Title		
Dual DC Photodiode Amplifier		
Size	Number	Revision
B	D1200543	2
Date:	12/10/2013	Sheet 1 of 2
File:	D:\Users\...\DualPDamp1.SchDoc	Drawn By: Daniel Hoak

Title Dual DC Photodiode Amplifier		
Size B	Number D1200543	Revision 2
Date: 12/10/2013	Sheet2 of 2	
File: D:\Users\...\DualPDamp2.SchDoc	Drawn By: Daniel Hoak

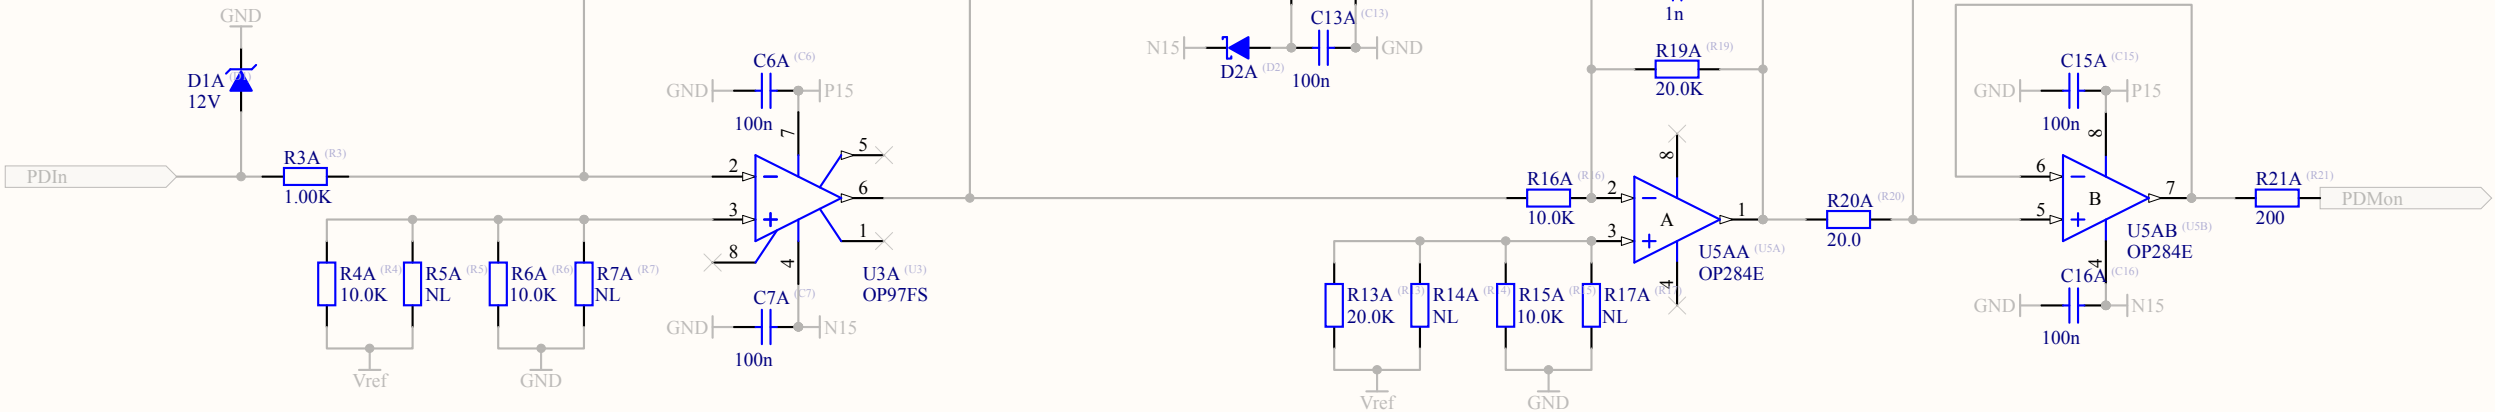
Transimpedance Gains reduced by 10 for increased laser power (40W).
Further increases in laser power will require further reductions in gain.
